APPLICATION NUMBER	PDP20-0002		
APPLICATION (PROJECT) NAME	WESTPORT WEST (WESTPORT LOGISTICS CENTER)		
APPLICANT NAME	TRISTAR PROPERTY ACQUISITIONS, LLC		
	12647 Olive Blvd., Suite 510, St. Louis, MO 63141		
PROPERTY OWNER(s) NAME	Kathleen K. Tuttle, Arthur L. Sitton		
APPLICANT'S REQUEST	Consideration of a Preliminary Development Plan in a PDM Planned District - Manufacturing district to allow a mix of office distribution and light industrial land uses at 15737-15888 River Valley Drive and 810 John Pellet Court.		
SITE LOCATION	River Valley Drive, John Pellet Court		
PARCEL/LOCATOR NUMBERS	15R640021, 15Q430021, 14R320032, 14Q110014		
EXISTING ZONING DISTRICT	NU - Non-Urban		
TOTAL SITE AREA	136.7 acres		
PLANNING AREA	MARYLAND PARK LAKE DISTRICT		
REPORT ISSUED	October 21, 2020		
CASE MANAGER	Hilary Perkins, AICP		
RECOMMENDATION	APPROVAL		
1 KT			
	HOG:HOLEOW:RD:		
A 2 Set	AMEREAURA

APPLICATION PDP20-0002 October 21, 2020

## **REPORT TO PLANNING & ZONING COMMISSION** CITY OF MARYLAND HEIGHTS

FIGURE 6: BUILDING RENDERINGS

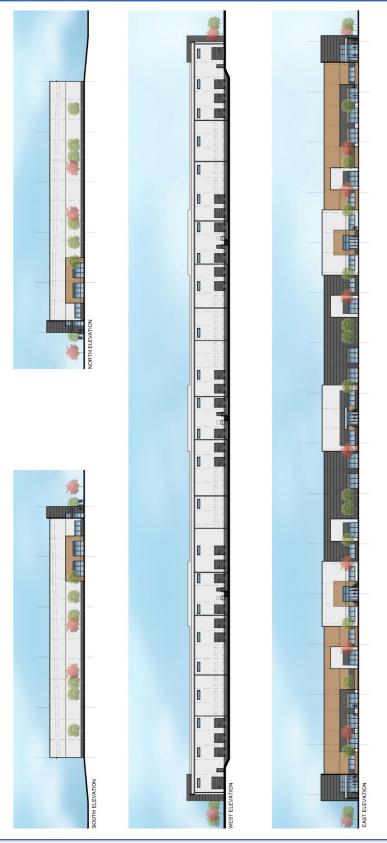
4. The City Planner finds that the building design is generally consistent with the purpose and intent of the Building Design Standards, subject to the review of architectural elevations for each building.
